Appendix A

Response-to-Comment Table

Comments from Related Departments

Job Title			APPENDIX B
S12A Man Kam To DD82 & DD87			
Date	Scale	Drawing Title	
16JUL26	1:1000@A3	PROPOSED ROAD LAYOUT AND CONTOUR PLAN AT JUNCTION J15	
Drawn	Job No.		
WSTW	287082-02

TITLE
TRAFFIC SIGNAL AND DUCTING DETAILS - SUI WAN ROAD AND SHA TAU KOK ROAD

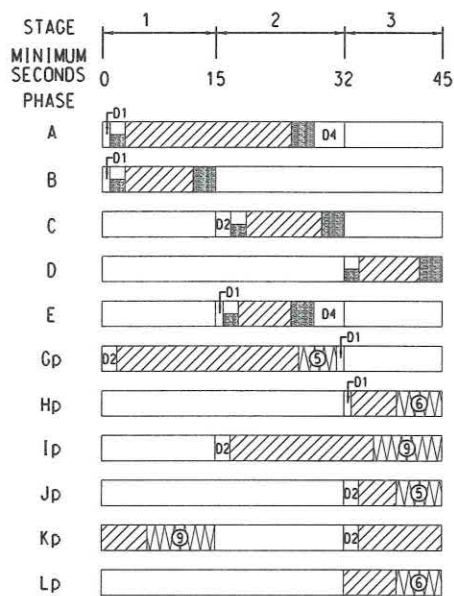
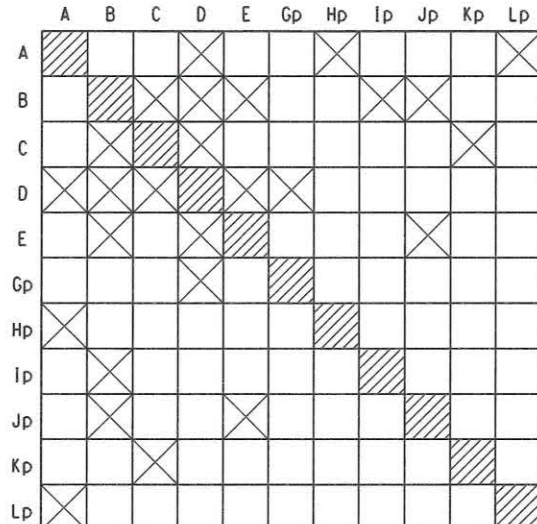
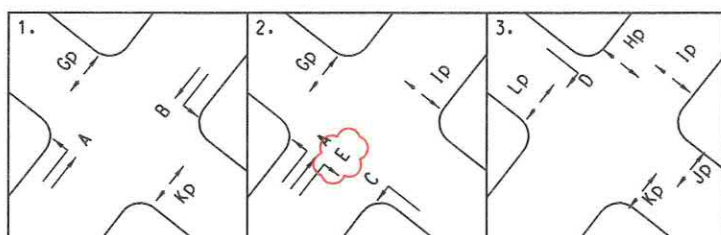
While we are preparing the traffic impact assessment for the captioned project, it is noted that there will be junction improvement scheme for the Junction of Sha Tau Kok Road / Sui Wan Road. We would like to seek your advice on the detailed modification works, change on the Method-of-Control (MOC) Plan (if any), and the implementation year.

Please note that according to our original scope of works, the junction of Sha Tau Kok Road and Ma Sik Road was scheduled to be modified from a 4-stage to 3-stage MOC to enhance junction performance.

Since the commencement of the contract, we have closely monitored this junction and reviewed the necessity of the proposed MOC modification. As the current performance of RC remains satisfactory even after the opening of the Fanling Bypass on 3 May 2026, we currently plan not to proceed with the MOC modification under this contract.

Nevertheless, I have attached the original proposed MOC modification for your reference.

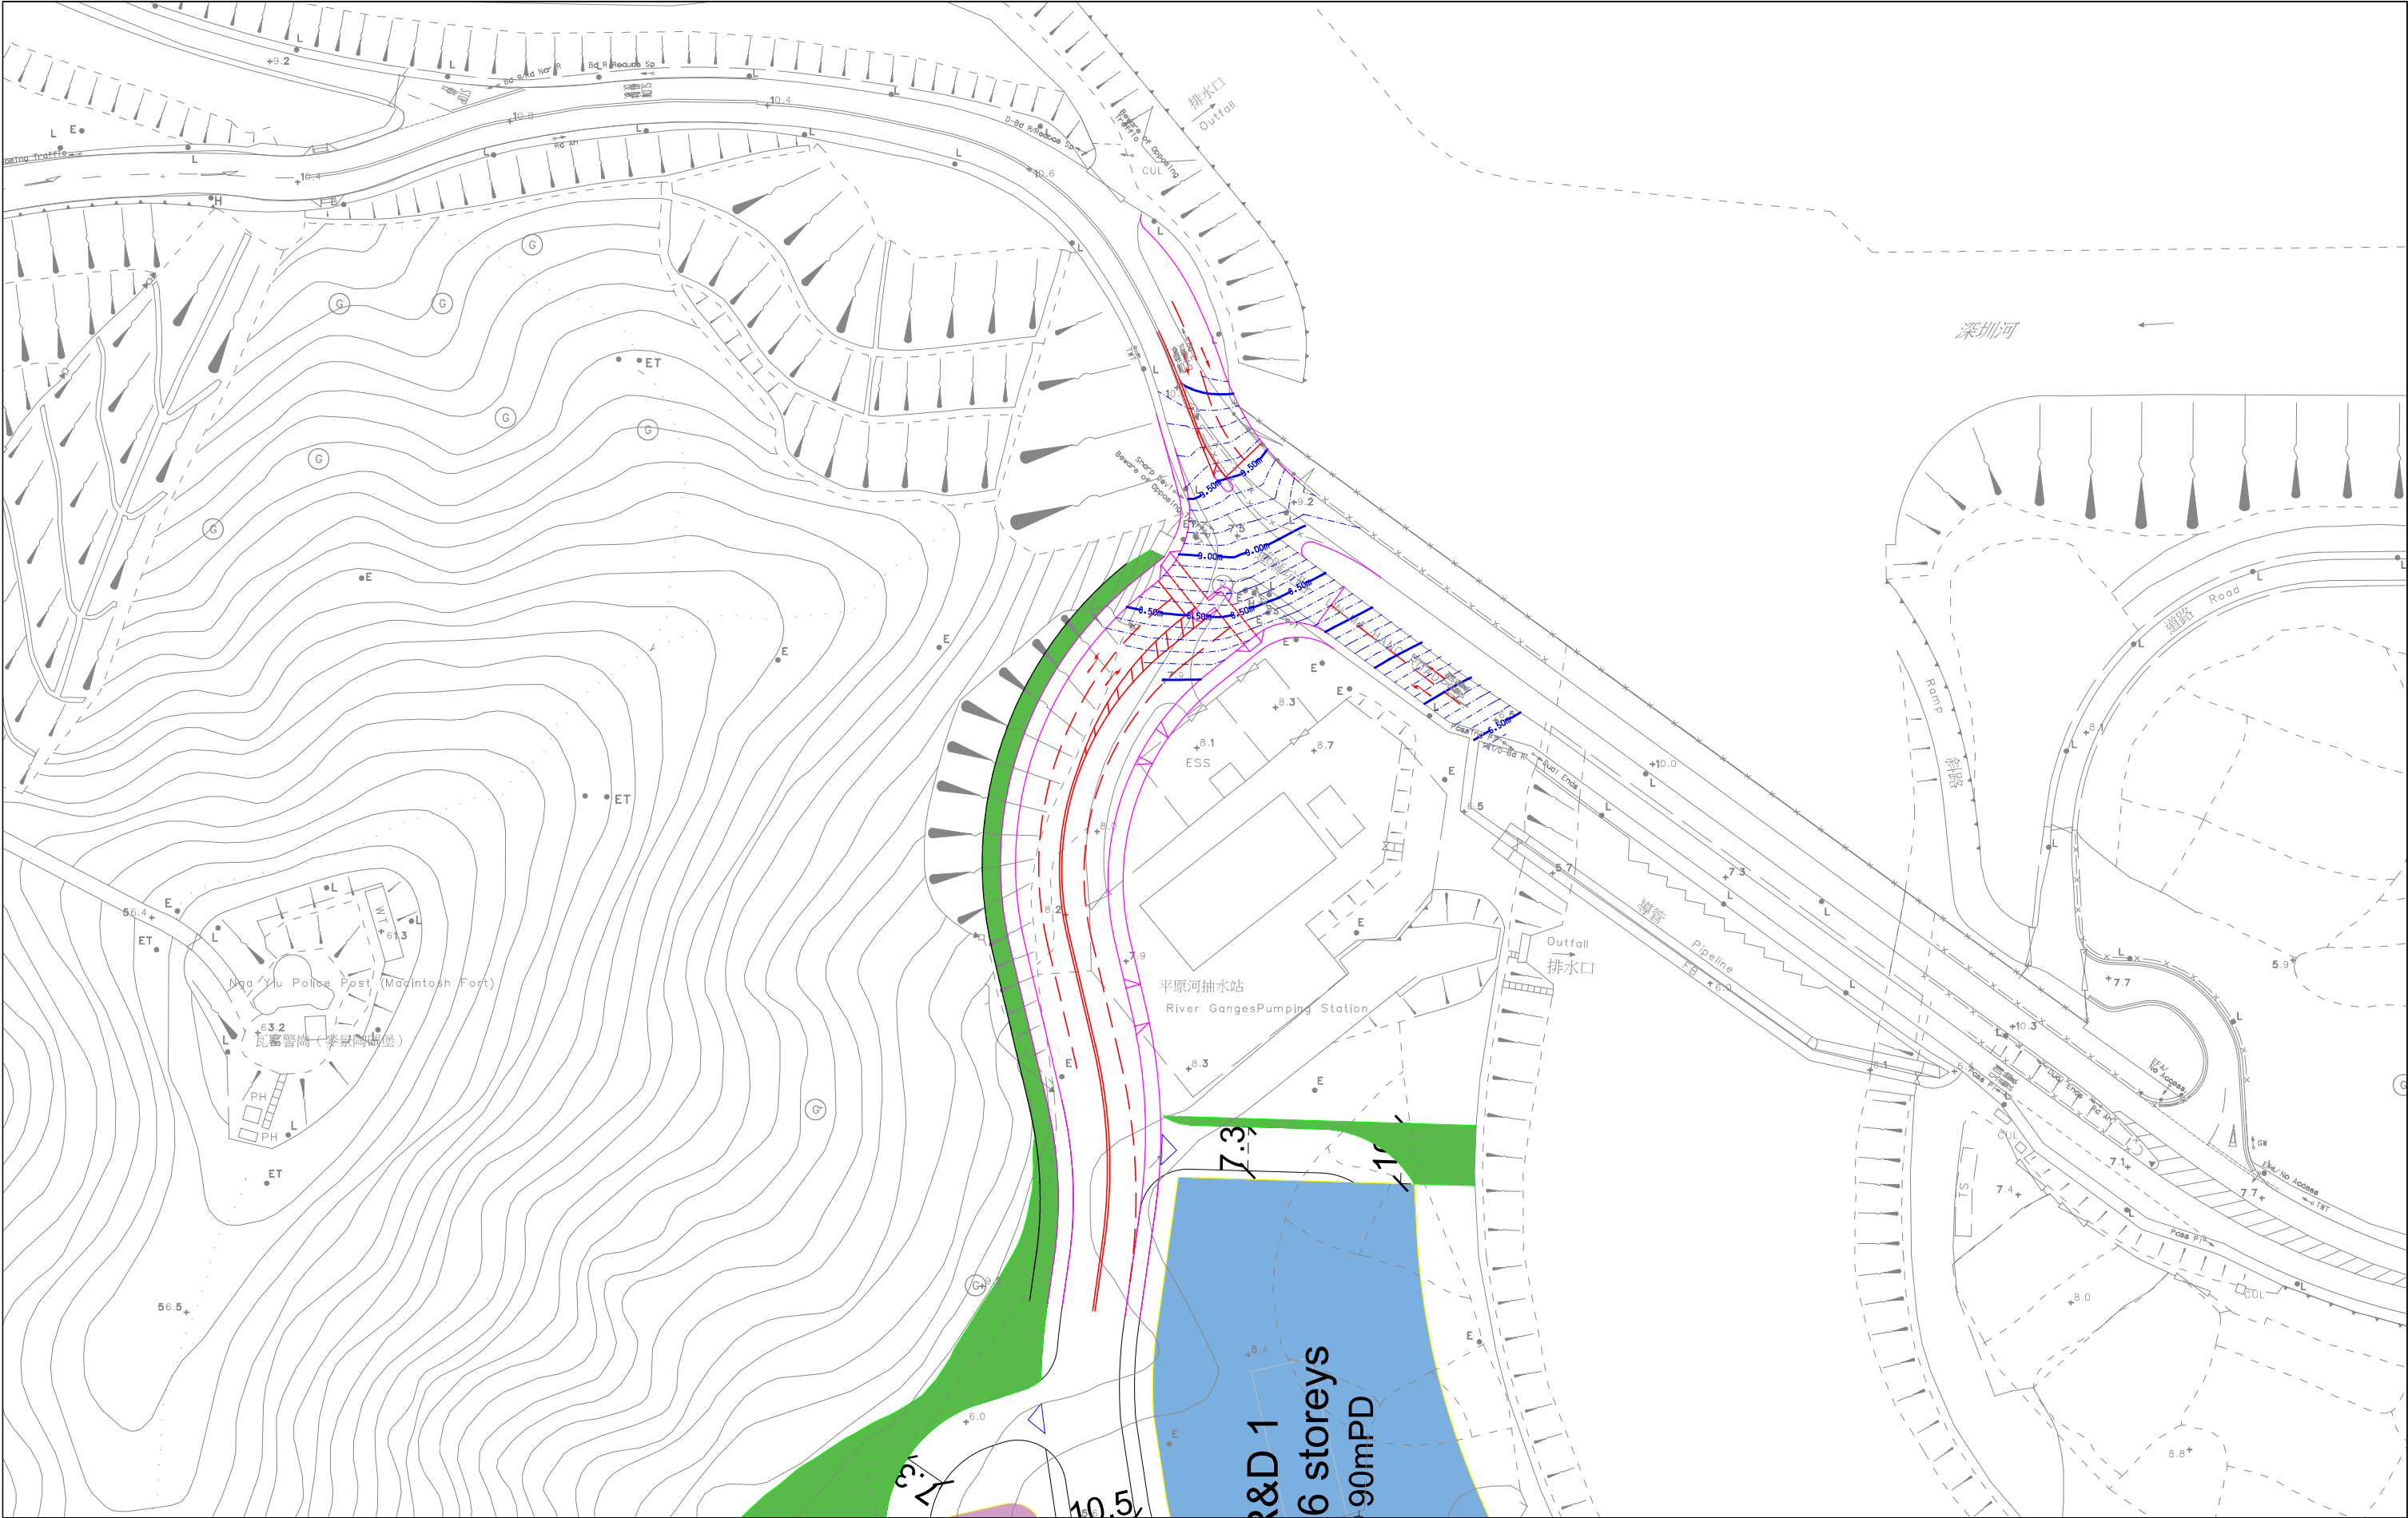
No.	Comments	Responses
	2. Figure 4.11 – The swept path encroaches into the opposite lane. The applicant should review and revise the swept path accordingly; 3. Junction J15 - Signalized staggered junction is located at the application site. The maintenance and management arrangement, as well as the associated land issues, will be further discussed at later stage; and 4. The applicant should justify the constructability of the proposed road improvement works in particular Junction J15.	The visibility analysis with 70m sight line to demonstrate the technical feasibility of the concerned replacement is presented in Figure 4.9 of the revised TIA report. Noted and revised accordingly. Please kindly refer to Figure 4.12 of the revised TIA report. Noted. A contour plan of the proposed Junction J15 has been prepared to demonstrate the constructability of the proposed road improvement works of Junction J15 with a gradient of 5%, which fulfils the TPDM requirement regarding the gradient on bus routes. Please kindly refer to Attachment B of this RtoC.
